# East Branch DuPage River Trail

The first Steering Committee (SC) meeting for the East Branch DuPage River Trail (EBDRT) Alignment Study was held on Wednesday, July 24<sup>th</sup>, 2019 from 1:00 p.m. to 3:00 p.m. at the Glen Ellyn Police Department Community Room, 65 S. Park Boulevard, Glen Ellyn, IL 60137. The main objective of this SC meeting was to provide a project overview, discuss alternatives to be analyzed, study area issues and concerns, and project goals. A total of 11 SC members attended. A list of meeting attendees is provided within this meeting summary.

SHEET 2 EVALUATION

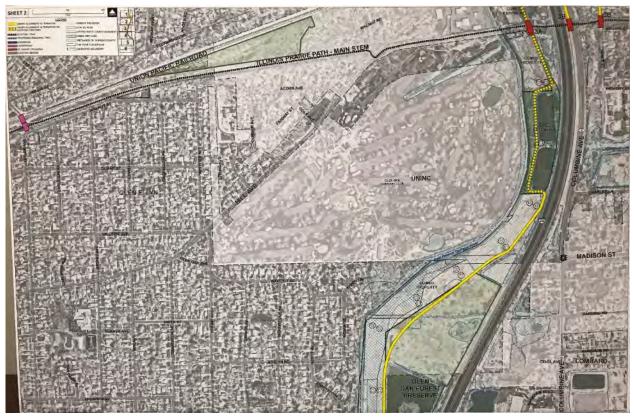
- **Glenbard Wastewater Treatment Plant:** Lombard concurred with siting path along or adjacent to the existing driveway to minimize impacts to other areas. Concerns would be maintaining security of the Glenbard Wastewater Treatment Plant by relocating the fence along the west side of the access road to the east side of the access road and separation of vehicles and bicyclists.
- South of the lagoons the ground level drops off into a wide floodplain/wetland area. A boardwalk structure may be necessary to minimize wetland impacts within the ComEd ROW.

INPUT SECURITY OF GLEVEARD WASTEWATER PLANT MUST BE MAINTAINED

BOARDWALK STRUCTURES ARE FEASIBLE TO REDUCE WETCHIS AND PLOODPLIN IMPACTS

- Consideration must be given whether maintenance vehicles will use the shared trail, bridges, or boardwalks for ComEd tower access. Designing for an H-20 truck is recommended to accommodate maintenance trucks while a design for an H-5 truck is acceptable if maintenance vehicles are not using the trail.

- ComEd confirmed that a 20-foot offset from the proposed trail to any ComEd towers is desirable. Less than 20-feet can be considered if necessary but will be evaluated on a case-by-case basis. The 20-foot offset recommended is to the outside base of the structure, therefore a wider offset is needed to the structure center for a lattice-type base.

- In areas where the EBDRT could be within ComEd right-of-way, ComEd concurs with generally following the location of existing unpaved paths used by ComEd vehicles. Concerns to be addressed to withstand utility vehicle traffic include path material, path width, width and design loading of any trail bridges, and potential pull-out areas near towers to separate maintenance vehicles from trail users. ComEd noted that the trail may need to be closed when they need to do major maintenance work and that the group should consider detour routes for when that occurs.

Determine any locations where path is closer than 20 feet to the outside of ComEd towers to discuss with ComEd.

SHEET 3 EVALUATION

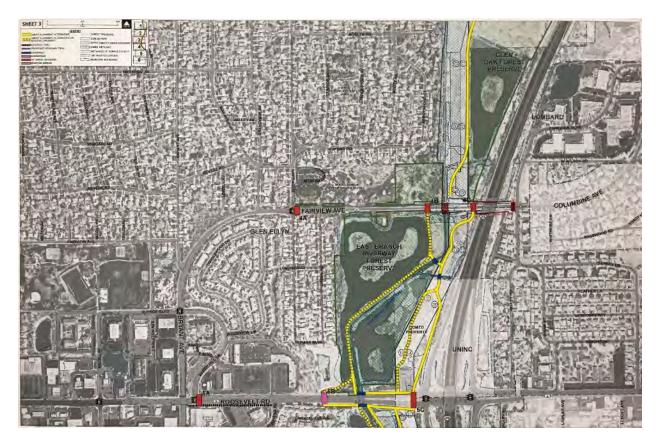
- Verify if the east or west cell can be used for a path crossing under IL-53.
- There is a proposed traffic signal at Surrey Drive east of I-355 which could be used as a proposed at-grade crossing with I-355 abutment modifications.

**CROSSING 4** 4A - 4C - VERIFY USE OF CULVER T EXPANSION UNDER IL-53, OR USE OF ENSTING STRUCTURE.

POTENTIAL OPTION FOR CROSSING TL-53 AT SURREY DR AT-GRADE, IL-53 AT SUERCY DR AT-GRU IF I-355 BRIDGE ABUTMENTS ARE WIDE ENEWGH

- Add at-grade traffic signal crossing alternative at Surrey Drive.
- The project team will coordinate with IDOT to get information on the proposed signal at IL 53 and Surrey.
- The project team will complete a concept elevation study for potential underpasses at IL 53. The objective is to determine if an underpass is feasible, the most suitable location, level of flood protection that is achievable, and whether any increase in roadway elevation would be required.

SHEET 6 EVALUATION

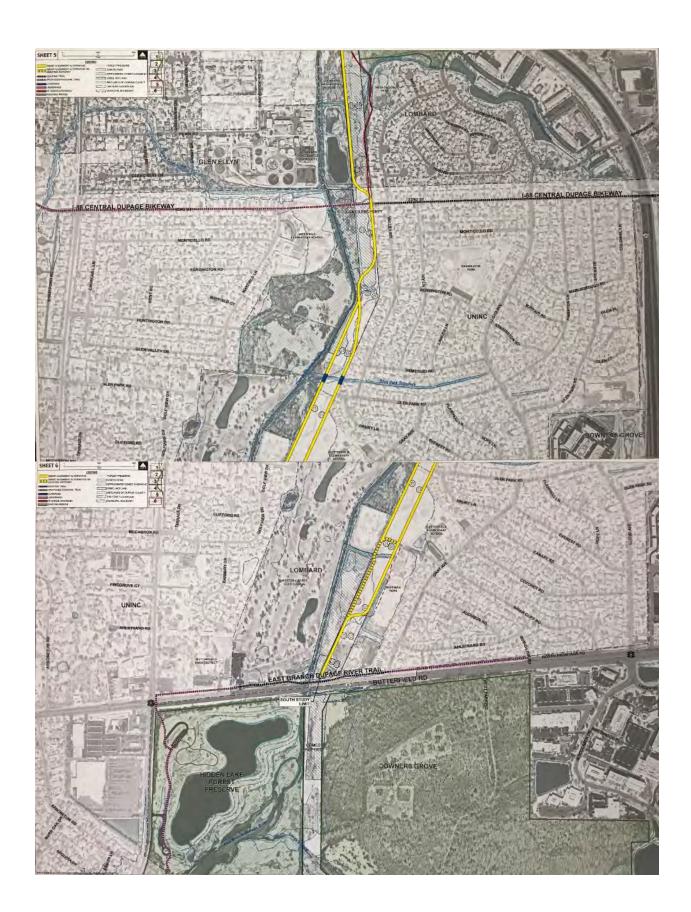
- The existing ComEd access roads are generally aligned along the west side of the corridor, however an east alignment may reduce floodplain impacts and provide easier access to Brentwood Park and potential future connections.
- IDOT plans to reconstruct the existing bike path along the north side of Butterfield Road and extend the path limits further east as part of the IL 56 improvements.
- An underpass was suggested for the trail to cross under IL 56.

- INVESTIGATE IDOT PLANS FOR BUTTERFIELD ROAD INPROVEMENTS AND ENSTANG TRAIL EXTENSION.

- Obtain IDOT roadway plans to confirm the planned IL 56 connection. Coordinate with IDOT why
  an underpass at IL 56 was not considered.
- Confirm east limits of the planned IL 56 multi-use path at Lloyd/Lacey.
- The project team will complete a concept elevation study for a potential underpass at IL 56. The objective is to determine if an underpass is feasible, the most suitable location, level of flood protection that is achievable, and whether any increase in roadway elevation would be required.

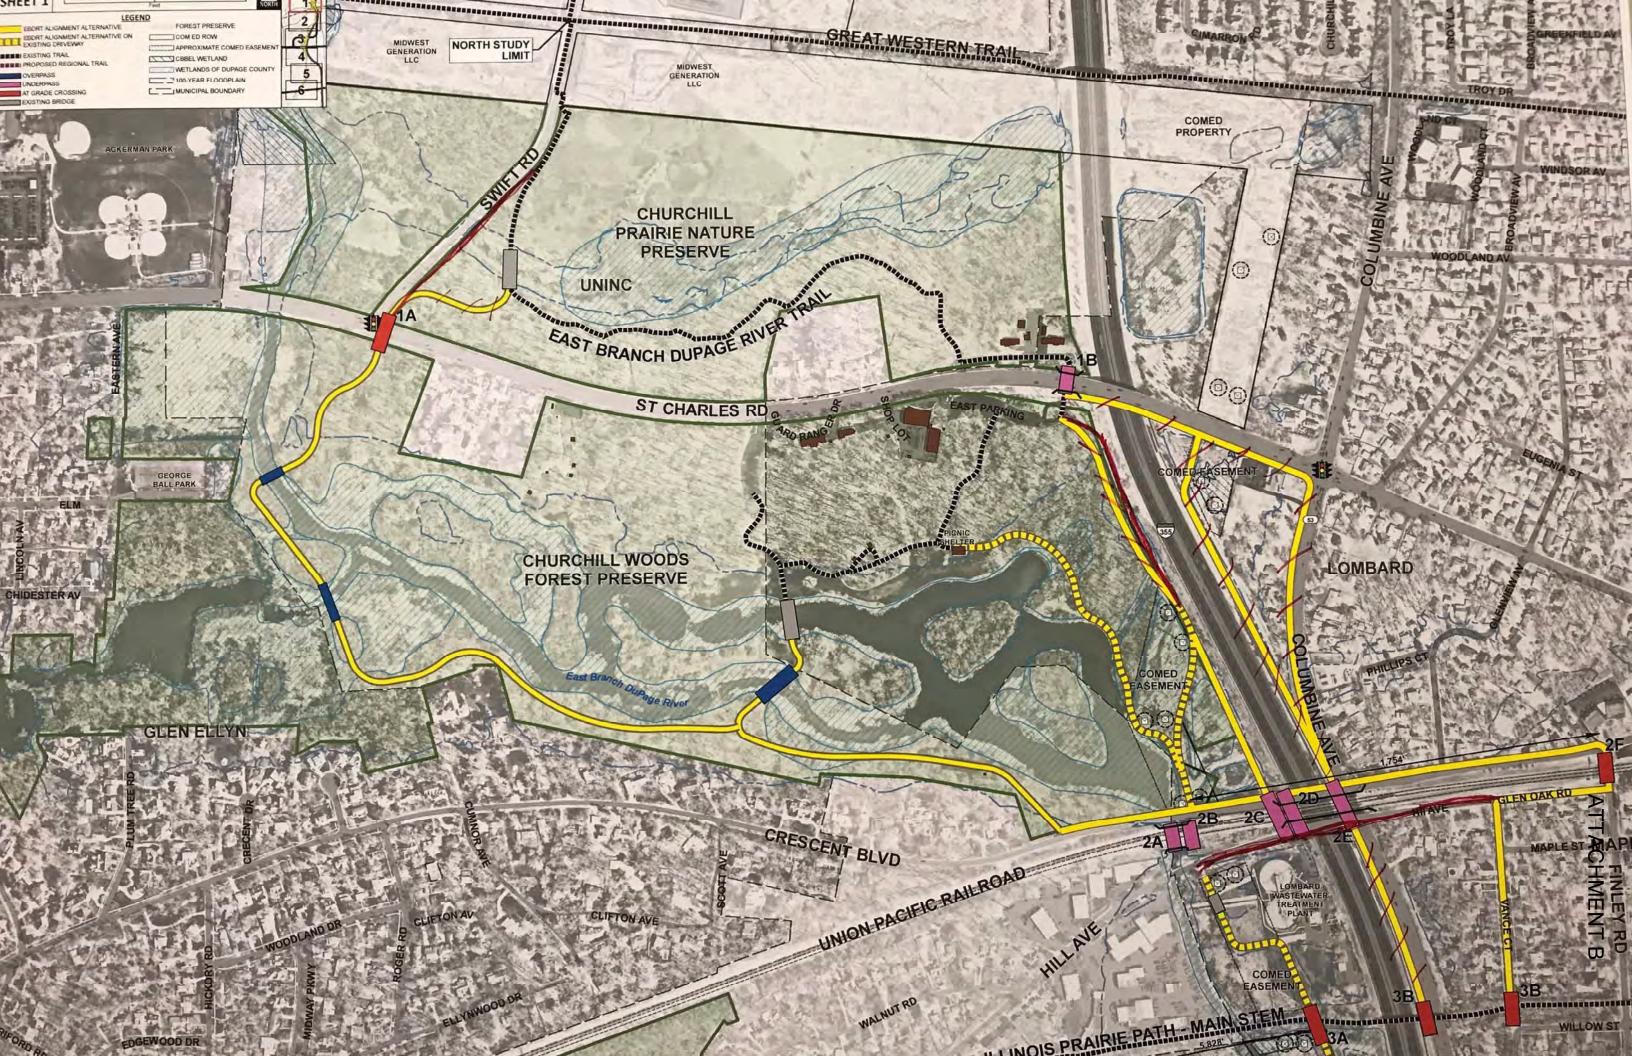
- Realign west alignment along Swift Road to avoid Nature Preserve impacts (Post Meeting Note: west alignment removed due to Nature Preserve and Class IV Ecosystem impacts)

- After discussion, the group concurred that the
  existing EBDRT north of St. Charles Road, and
  the existing culvert passage beneath St. Charles
  Road is acceptable. On this basis, and since any
  trail modifications in this area would be difficult
  based on the designated Churchill Prairie Nature
  Preserve, the current study will focus south of
  St. Charles Road.

- Class IV Ecosystems have the highest level of protection within forest preserves. All alignments between St. Charles Road and Crescent Blvd. involve Class III and Class IV Ecosystems.

- Realign alignment along west side of Tollway to be just inside Tollway ROW or at the east edge of FPDDC holdings (just outside Tollway ROW).
- STEERING COMMITTEE MEETING #1 JULY 24, 2019 ALTERNATIVES EVALUATION CRITERIA DISCUSSION SHEET 1 EVALUATION INPUT SWIFT RD CROSSING 1 UT ASSISTENT TO REASONS) SENSITIVE ECOSYSTEM IN THIS AREA, THEREFORE MAY NOT BE FEASIBLE. 1A - 1B SEGMENT 1 ST. CHARLES RD TO CRESCENT BLVD FOREST PRESERVE LEVEL OF PROTECTION JURISDICTION / MINITENANCE OF PATH **CROSSING 2** COMED VERT/HORIZ CLEARANCE 2A - 2E JA IMPEDENCE OF FLOW STRUCTURALLY SOUND (ENSTAIR CRESCENT RO-WARE STRUCTURE) TO SE VERTIFIED IN PRICE I POTENTIAL ADDITIONAL ALLCHMENT ALONG HILL AND (FROM CROSSING DF AT FINLEY RD) SEGMENT 2 -ALL ALIGNMENTS EAST OF I-355 ARE UNDESTREATED HILL AVE TO ILLINOIS PRAIRIE PATH

- Will need to complete a hydraulic study in Phase I to demonstrate Crossing 2A (within the
  existing EBDR culvert will not cause a flow impedance and is structurally sound.

- Add alignment along Hill Avenue to bring Alt 2F Finley Road crossing back to EBDRT, however crossing 2F Finley Road is not preferable considering potential conflicts with free flow traffic from Finley Road and existing sidewalk grade differences

- All trail alignments east of I-355 are not preferred and were removed.
- The SC concurred that further study should be done to find out whether or not there is a
  feasible alternative within the east cell of the UPRR underpass. Key issues will be ADA
  accommodations, level of flood protection, and stormwater permitting, etc.

SHEET 1 EVALUATION	INPUT
CROSSING 1 1A - 1B	- SWIFT RD (EXPLORE ALIGNMENT ADJACENT TO ROADWAY) SENSITIVE ECOSYSTEM IN THIS AREA, THEREFORE MAY NOT BE FEASIBLE.
SEGMENT 1 ST. CHARLES RD TO CRESCENT BLVD	- TOLLWAY ROW ALIGNMENT SOUTH OF ST. CHARLES ROAD, NOT FOREST PRESERVE -FOREST PRESERVE LEVEL OF PROTECTION -JURISDICTION/MAINTENANCE OF PATH
CROSSING 2 2A - 2E	- COMED VERT/HORIZ. CLEARANCE TO BE CONFIRMED.  - JA: IMPEDENCE OF FLOW, STRUCTURALLY SOUND (EXISTING CRESCENT RD + UPRR STRUCTURES) TO BE VERIFIED IN PHASE I.
SEGMENT 2  HILL AVE TO ILLINOIS PRAIRIE PATH	- POTENTIAL ADDITIONAL ALIGNMENT ALONG HILL AVE (FROM CROSSING QF AT FINLEY RD)  - ALL ALIGNMENTS EAST OF I-355 ARE UNDESIREABLE

- An exhibit will be generated showing classifications with pictures of the existing access road and provided to the FPDDC for internal review.
- Confirm enough room for alignment along the Tollway R.O.W. considering future add-lanes.
- The project team will complete a concept elevation study for potential underpasses at Crescent/UPRR/Hill. The objective is to determine if an underpass is feasible, the most suitable location, level of flood protection that is achievable, and whether any increase in roadway elevation would be required.

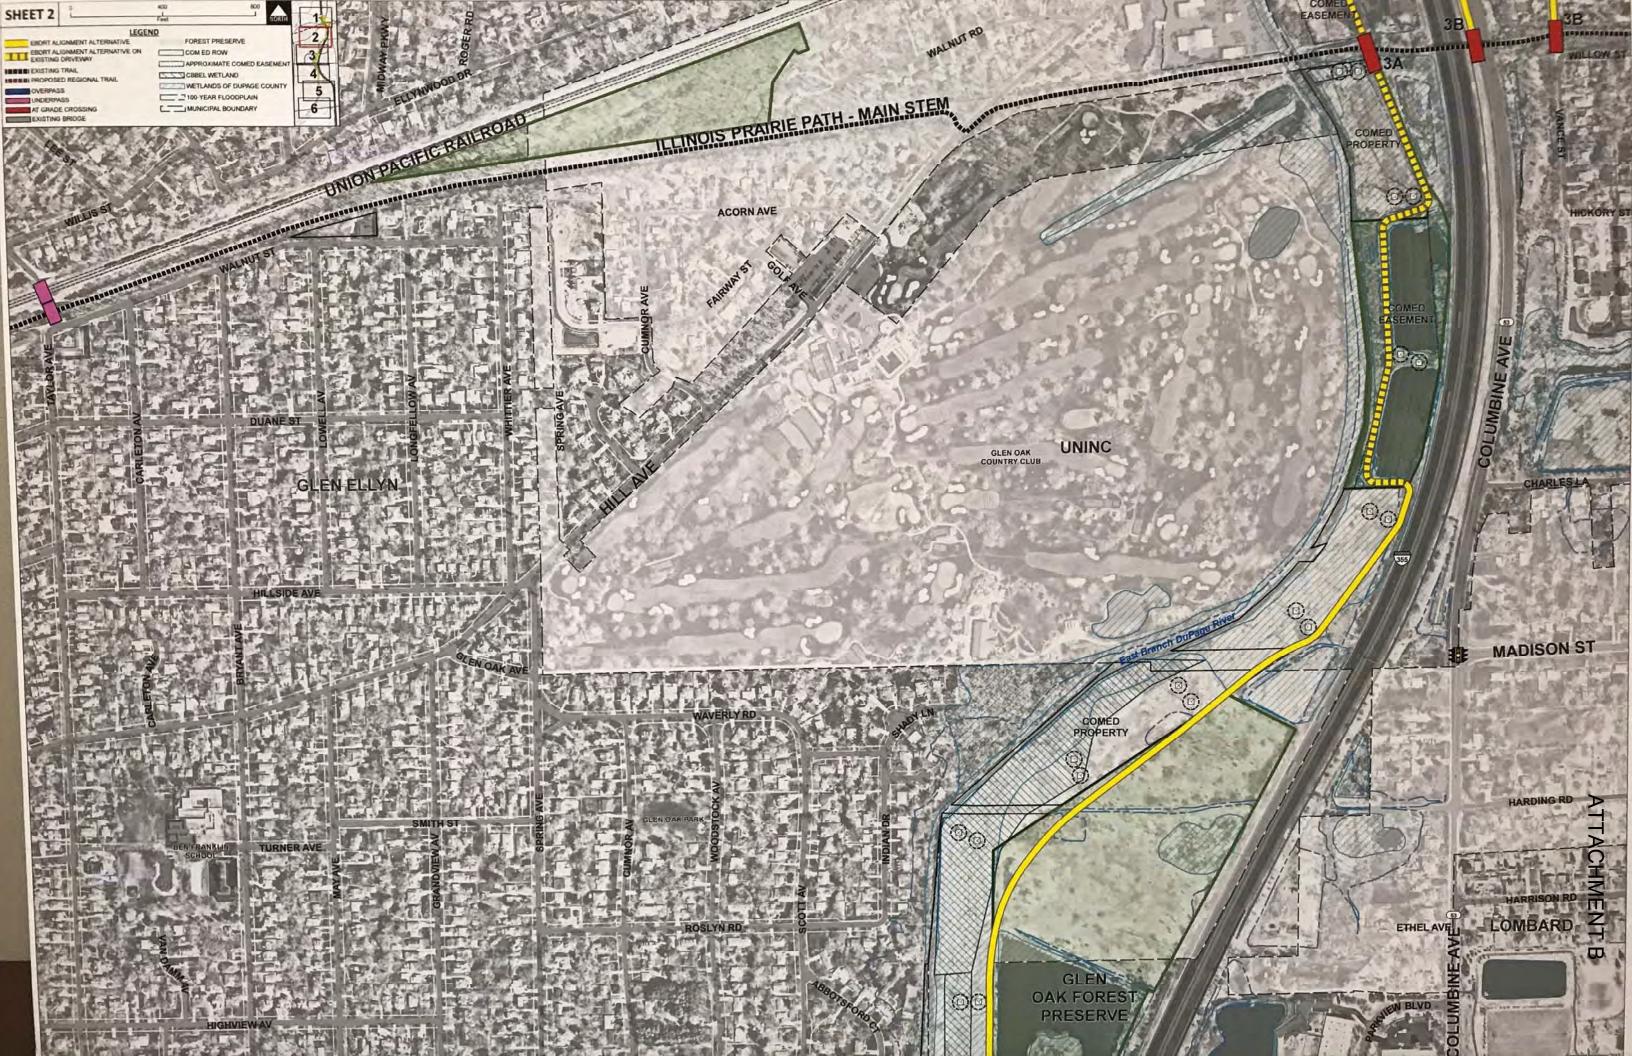
CRITERIA DISCUSSION				
SHEET 2 EVALUATION	INPUT			
CROSSING 3 3A - 3B	- SECURITY OF GLENBARD  WASTEWATER PLANT MUST  BE MAINTAINED			
SEGMENT 3 ILLINOIS PRAIRIE PATH TO IL-53	- HOO LOADING (COMED) FOR SHARED  CLOSMIG FOR MAINTENANCE MAY BE AN ISSUE.  BOARDWALK STRUCTURES ARE FEASIBLE TO REDUCE WETZAND AND FLOODPLAIN IMPACTS.

SHEET 4 EVALUATION

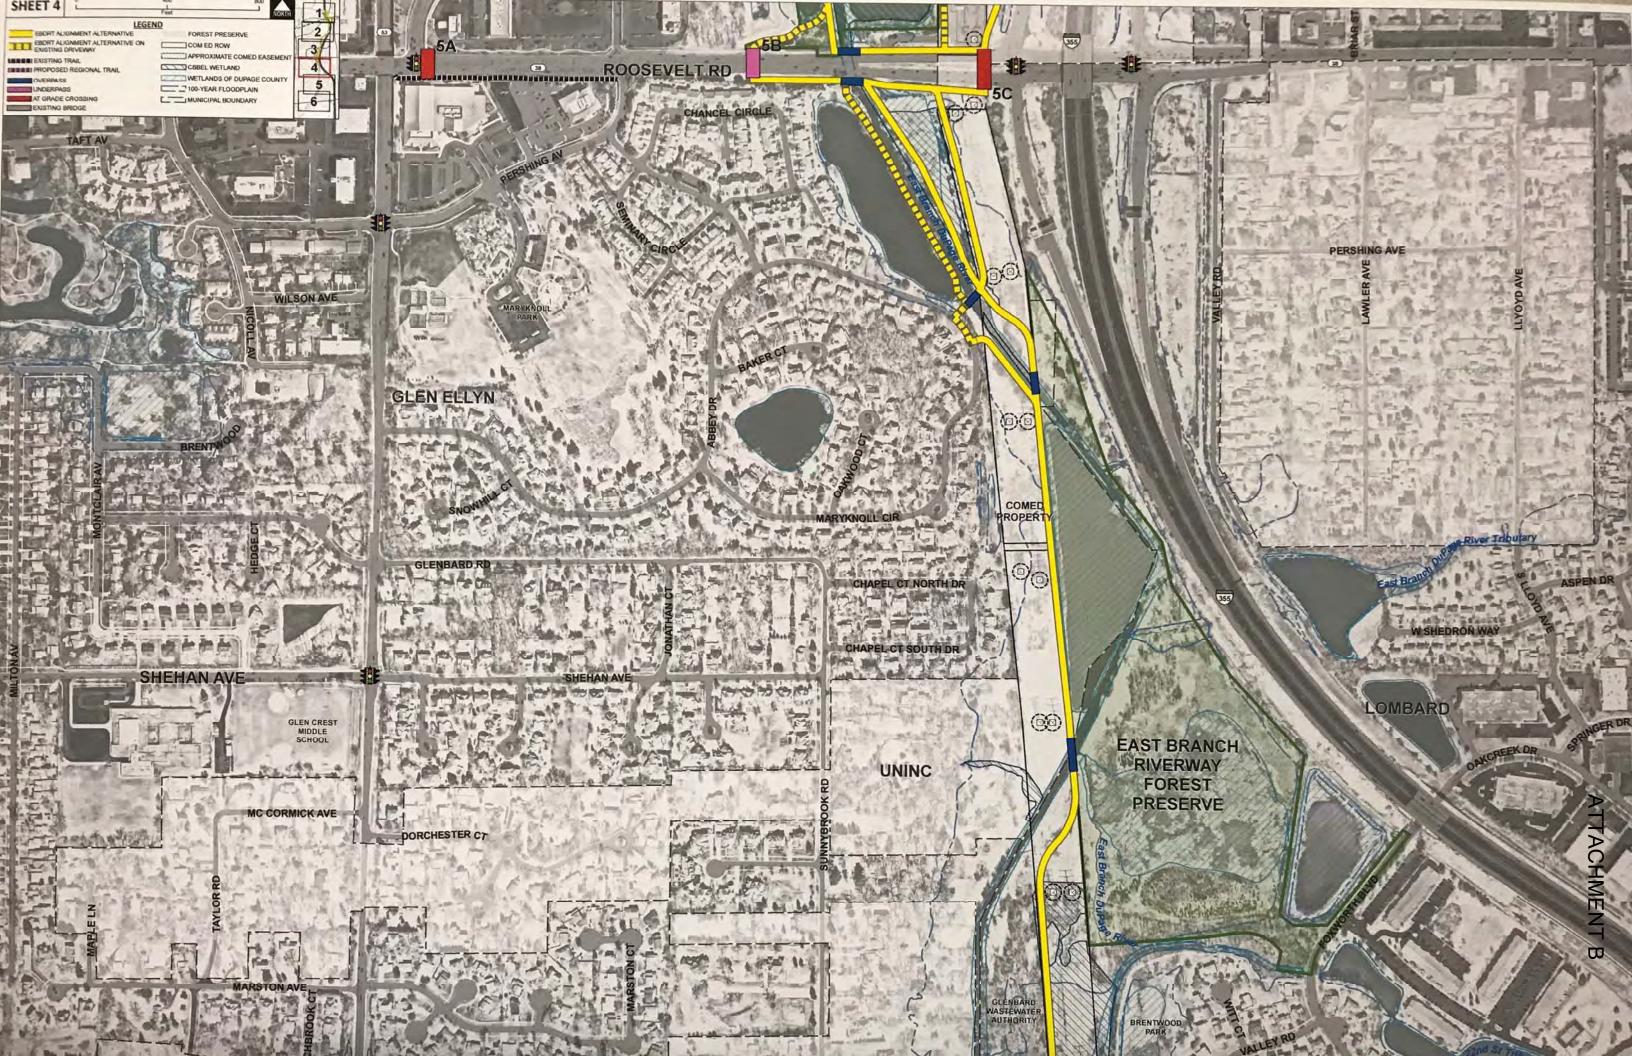
- An at-grade crossing of Roosevelt Road at I-355 was generally the least preferred alternative.
- Using the existing path along the west side of the EBDR would require 2 fewer pedestrian bridges than the east 2 alignments.

The project team will complete a concept elevation study for potential underpasses at IL 38. The objective is to determine if an underpass is feasible, the most suitable location, level of flood protection that is achievable, and whether any increase in roadway elevation would be required.

CINILINAL	DISCUSSION
SHEET 6 EVALUATION	INPUT
SEGMENT 6 (CONTINUED)	
PROJECT LIMIT BUTTERFIELD RD	- INVESTIGATE IDOT PLANS FOR BUTTERFIELD ROAD IMPROVEMENTS AND EXISTING TRAIL EXTENSION.

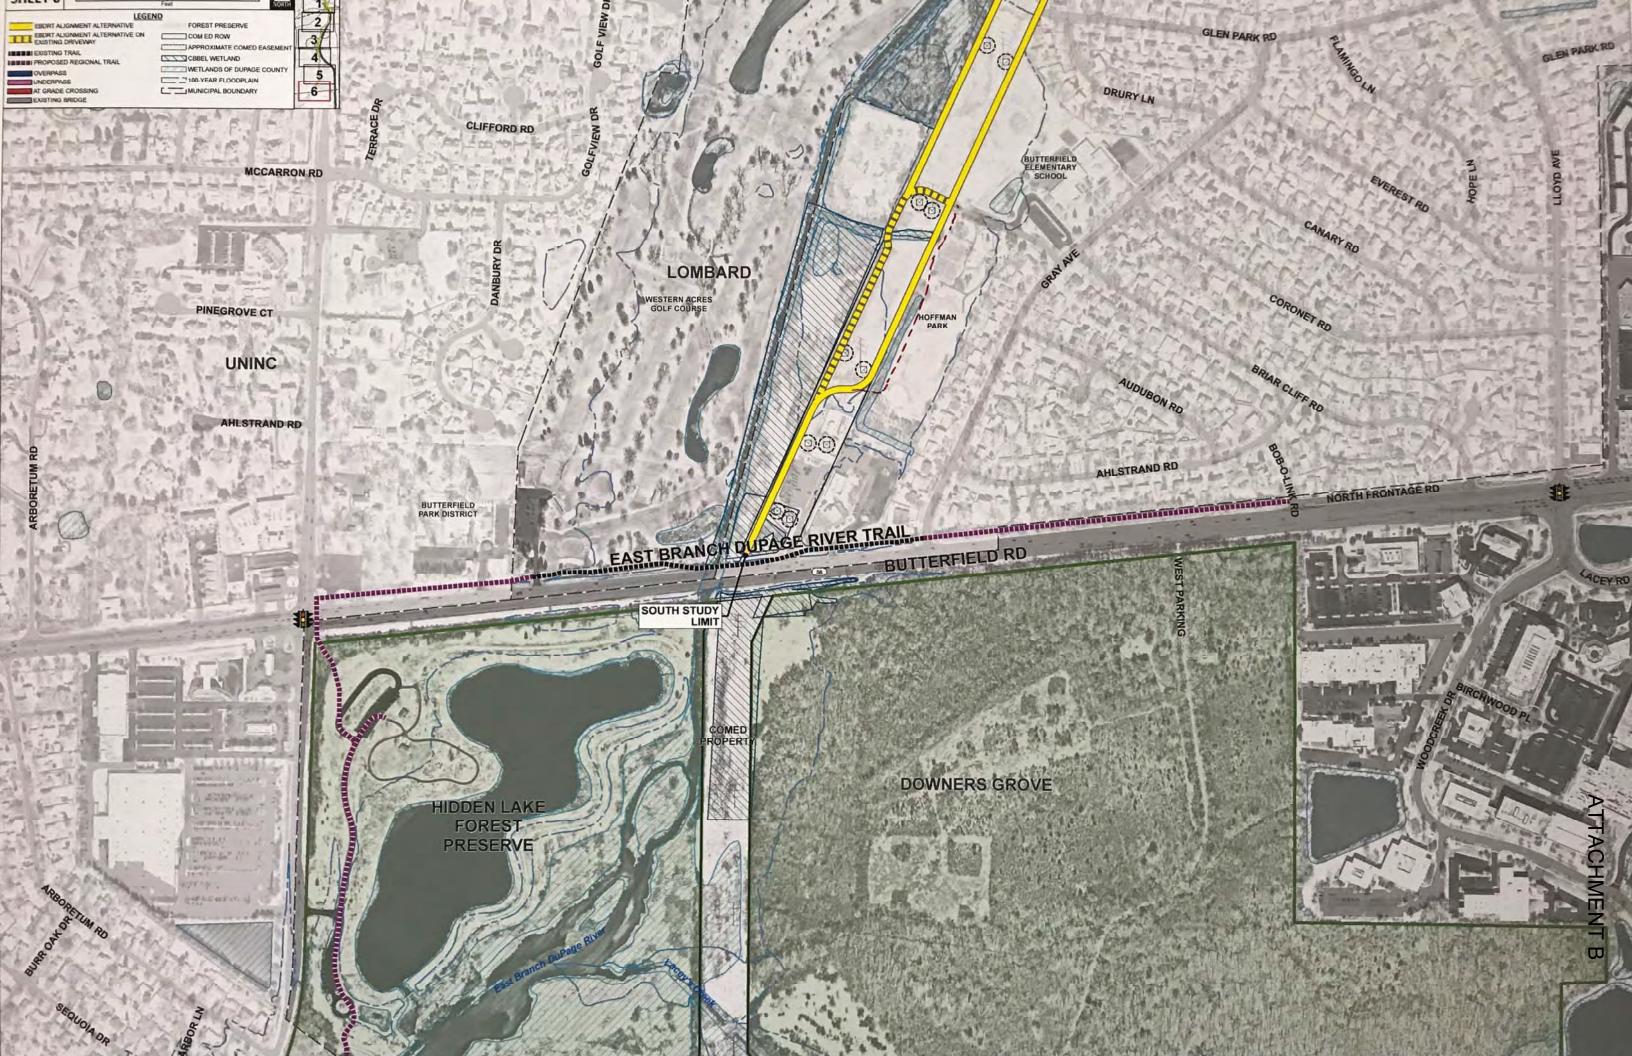
SEGMENT 5 (CONTINUED) - POTENTIAL TO KOUTE PATH TO EAST SIDE OF COMED PROPERTY TO MINIMIZE FLOODPLAIN IMPACTS AND ALLOW EASIER CONNECTION TO BRENTWOOD PARK.
